Access Compliance Report

Public Rights-of-Way

(Curb Ramps)

Intersection ID: 13395	Main Street: LOVE_AV	Cross Street: N_SHARON_AMITY_RD	Location: NW
ADA ID: 19A9A1DB0803	Ramp Type: Perp	Initial Pass/Fail: Fail	Overall Compliance: No
Severity Score: 48.75			
Codes/Mitigation Info/Possible Solution		Field Measurements/Component Compliance

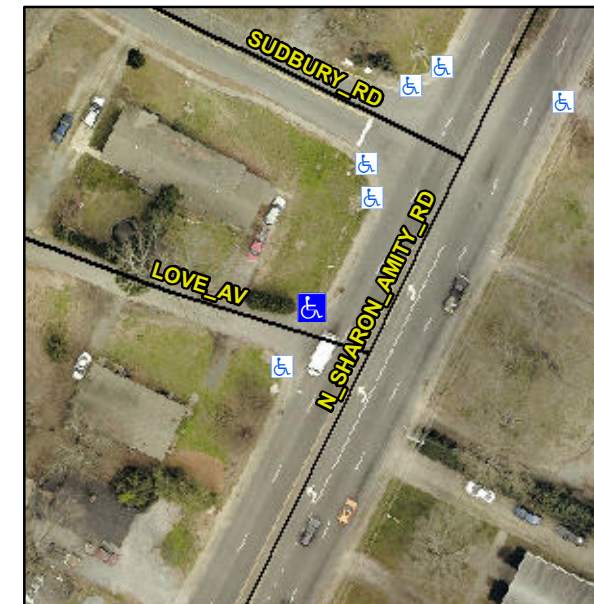
Not Found, R304.5.1, R304.2.2, R304.5.3

Compliance	Description	Data	Compliance	Description	Data
N/A	Ramp Length (in)	55.0	No	Ramp Slope (%)	11.9
No	Ramp Width (in)	30.0	No	Ramp XSlope (%)	2.4
N/A	Flare Type LT	N/A	N/A	Flare Type RT	N/A
N/A	Flare Slope LT (%)	N/A	N/A	Flare Slope RT (%)	N/A
N/A	Flare Traversable LT?	N/A	N/A	Flare Traversable RT?	N/A
N/A	Landing Length (in)	N/A	N/A	DWS Provided?	N/A
N/A	Landing Width (in)	N/A	N/A	DWS Contrast?	N/A
N/A	Landing Slope (%)	N/A	N/A	DWS Length (in)	N/A
N/A	Landing X Slope (%)	N/A	N/A	DWS Full Width?	N/A
N/A	Landing Curb? (Y/N)	N/A	N/A	DWS Offset (in)	N/A
N/A	Shared Landing?	N/A			
N/A	Gutter Ponding?	N/A	N/A	Gutter Slope (%)	N/A
N/A	Gutter Lip Ht (in)	0.5	N/A	Gutter X Slope (%)	N/A
N/A	Painted X Walk1?	No	N/A	Painted X Walk2?	N/A
	X Walk 1 Direction	To SW		X Walk 2 Direction	N/A
N/A	X Walk 1 Width (in)	N/A	N/A	X Walk 2 Width (in)	N/A
	X Walk 1 Slope (%)	0.4		X Walk 2 Slope (%)	N/A
	X Walk 1 X Slope (%)	1.9		X Walk 2 X Slope (%)	N/A

Remove & Replace Entire Ramp.
